**DEPARTMENT OF TRANSPORTATION
STATE OF GEORGIA**

FILE: BRST0-0005-05(047) Bryan Effingham **OFFICE:** Engineering Services
P.I. No.: 533145
SR 26/US 80 @ Ogeechee River **DATE:** June 22, 2010

SUBJECT: IMPLEMENTATION OF VALUE ENGINEERING STUDY ALTERNATIVES

SUBJECT VALUE ENGINEERING STUDY REPORT RESPONSE

STAGE I CROSS SECTIONS
STA 22+00 - 36+00

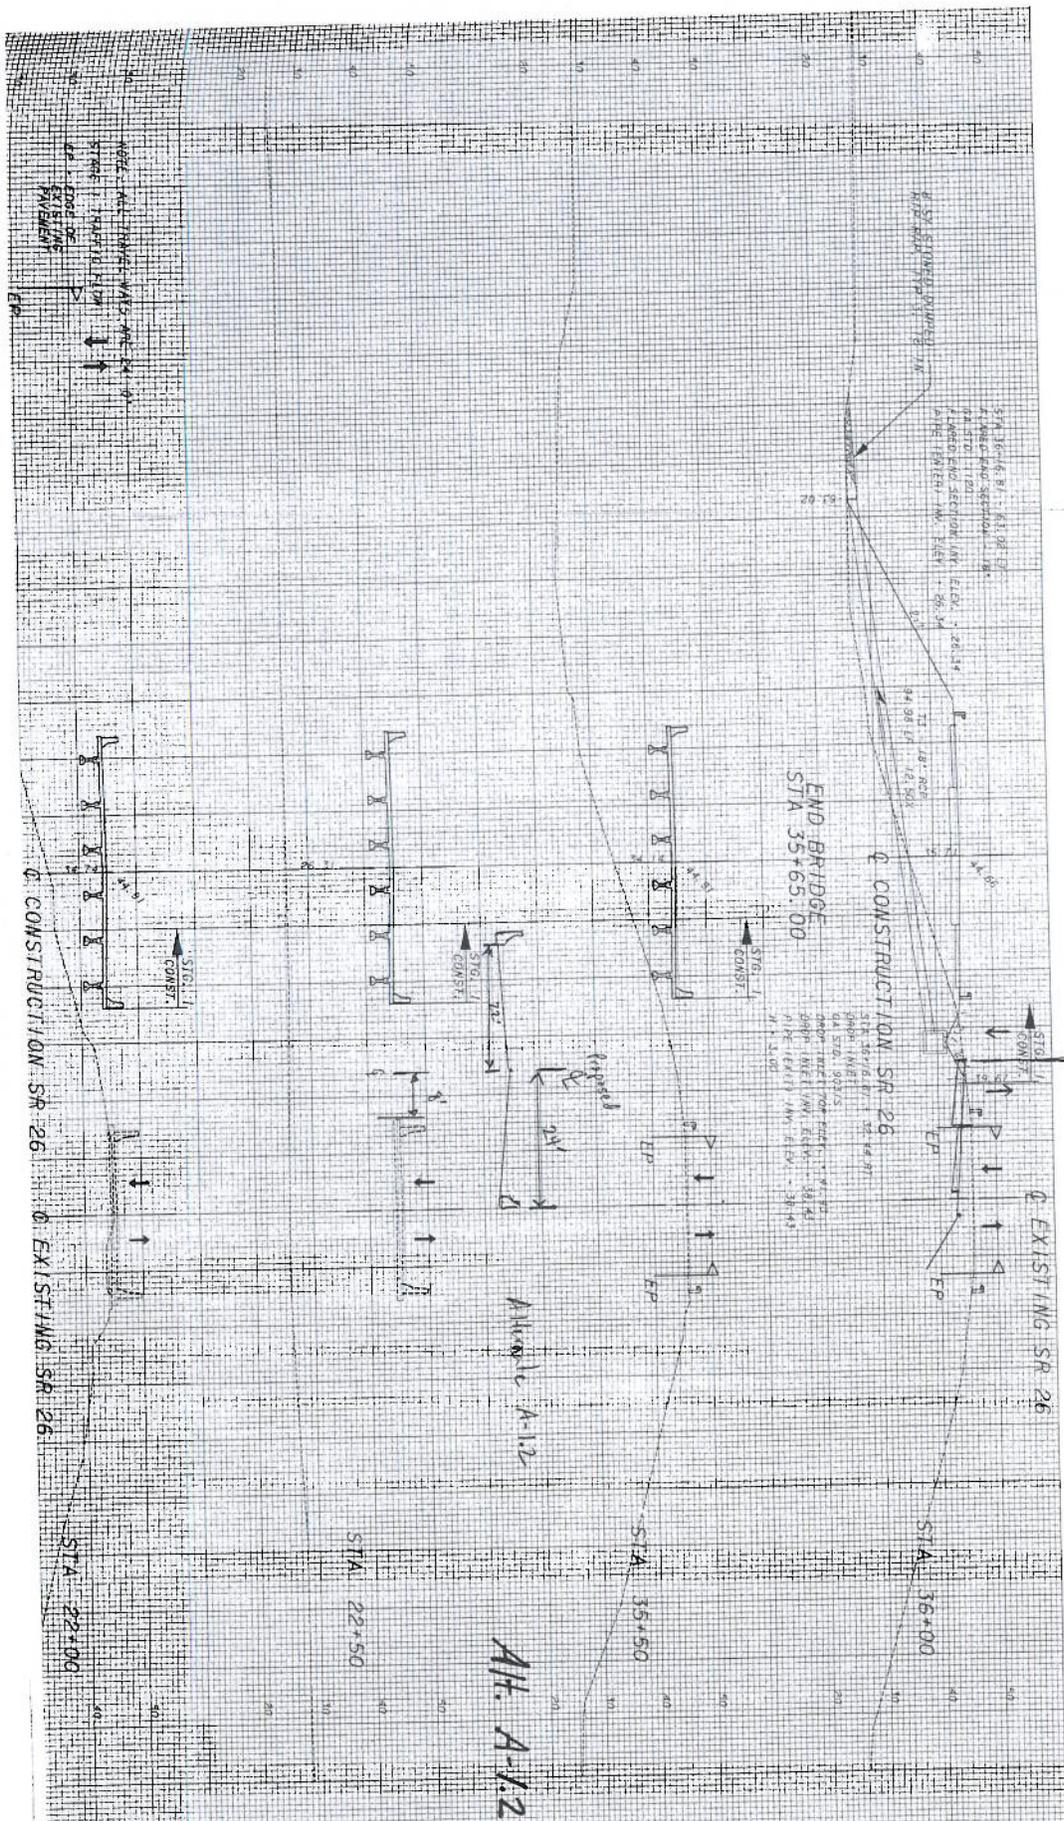
When looking at the roadway staging for this alternate, there will be concerns with the vertical grades and drainage between the two roads during staging. The proposed right edge of mainline paving and the left edge of the existing travel lane are both offset 12 foot from the proposed centerline (see attached cross section). The cross section shows that the proposed grades would have to be raised in order to construct the proposed road adjacent to the existing travel lane. This in turns means that the bridges would need to be raised, which will increase the cost of the project.

Recommendation: Do Not Implement. The issues with this alternate lie with the staging of the roadway and the drainage between the roadways. The proposed shoulder break point will be approximately 4 feet from the existing edge of paving (see attached staging cross section). Even if you wait to install the right paved shoulder under Stage 2 adjacent to traffic and under a flagging operation, there will be insufficient room for drainage storage between the roadways during Stage 1. The 60-foot alignment was chosen with the staging drainage in mind. The drainage between the roadways has to be directed via a ditch to each bridge end. The bridges are approximately 1000 feet apart and the existing grades are very flat.
